California-American Water

CORRESPONDENCE – APPLICANT

Re: September 17, 2020, Special Meeting Agenda Items Th3a & 4a:
Monterey Peninsula Water Supply Project, Coastal Development Permit
Application No. 9-19-0918, and Appeal No. A-3-MRA-19-0034

¹ The Applicant’s Staff Report is a redline against the August 25, 2020, Staff Report.

Figure 1 – Map of industrial uses/existing sites of pollution

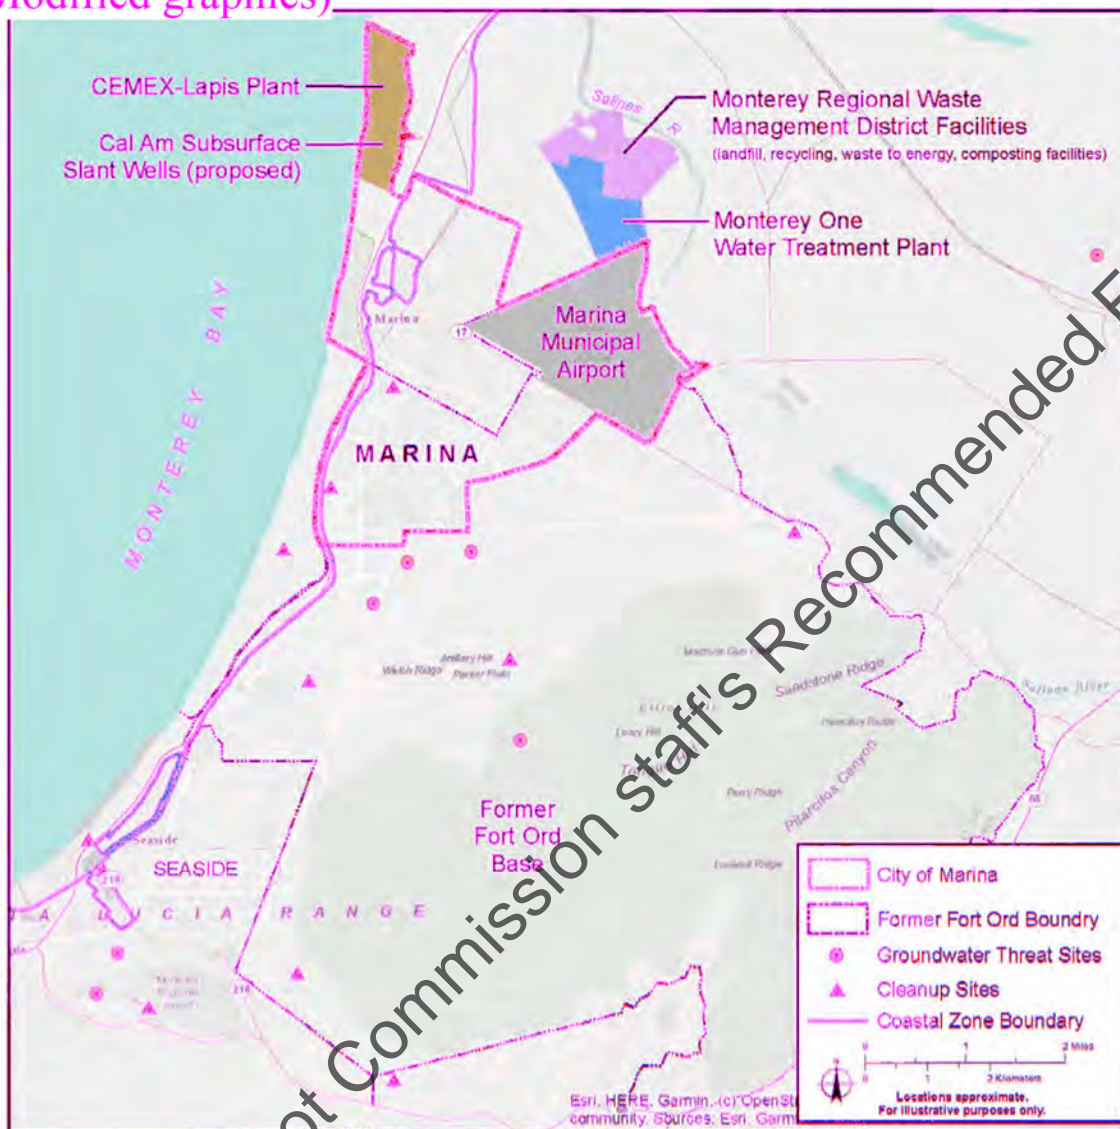
- As an initial matter, much of the industrial development that staff represents to be in Marina is not, in fact, within city limits. Figure 1 of the Staff Report shows that, although Marina is near a regional landfill, regional composting facility, and regional sewage plant, this industrial development is located outside of Marina's boundaries. (See Staff Report, p. 100; see also Applicant's Staff Report, Section IV.N.) Further, although Fort Ord is a contaminated site, Marina is actively working to develop the area with housing. (See Applicant's Staff Report, Section IV.N.)

- Second, as stated above, much of the industrial development is not, in fact, within city limits – it is *near* Marina. Figure 1 of the Staff Report shows that, although Marina is near a regional landfill, regional composting facility, and regional sewage plant, this industrial development is outside of Marina’s boundaries. (See Staff Report, p. 100; see also Applicant’s Staff Report, Section IV.N.) Further, although Fort Ord is a contaminated site, Marina is actively working to develop the area with housing. (See Applicant’s Staff Report, Section IV.N.) Even so, the Project’s *de minimis* presence would not contribute to cumulative impacts on Marina. (See Section G, *supra*.) The majority of the Project’s footprint and the physical desalination facility will be located outside of Marina.

Figure 1
Annual Water Production for Customer Service (Demand)
Last 20 Years
(Acre-Feet)

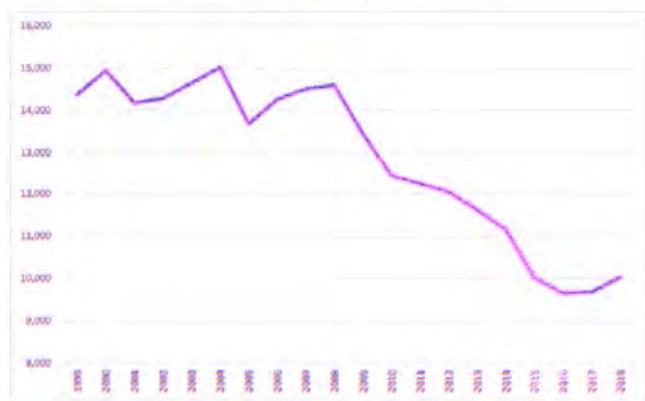
This graph also illustrates that calculating the 10-year average during the next several years will involve removing the higher demand years from 2008 to about 2015 and replacing them with lower demand years of 2019, 2020, and onward. As noted above, Cal-Am's recent testimony to the CPUC shows that it expects demand in 2020 through 2022 to remain at the low end of use – about 9,789 acre-feet per year – which results in the high demand during 2008 and 2009 of around 14,000 acre-feet being replaced by upcoming years of about 4,000 acre-feet less demand. Moving forward each year by deleting the earliest year of the 10-year period and adding a new year that includes the expected high estimate of 16.4 acre-feet per year of predicted growth (which, as noted in the Updates, is the highest rate over the past 20 years) results in the next several 10-year annual averages dropping well below the current 10-year average of 11,232 acre-feet per year – to a low of about 10,047 acre-feet in 2024.¹³²²¹³ It would then be expected to start increasing at the anticipated rate of growth. This approach puts the upcoming 10-year averages much closer to the existing five-year average used in the 2019 Update and allows for a relatively consistent comparison with the same approach used in the CPUC's reliance of the 10-year average. As described below, more recent use figures provided by Cal-Am show an even lower current baseline.
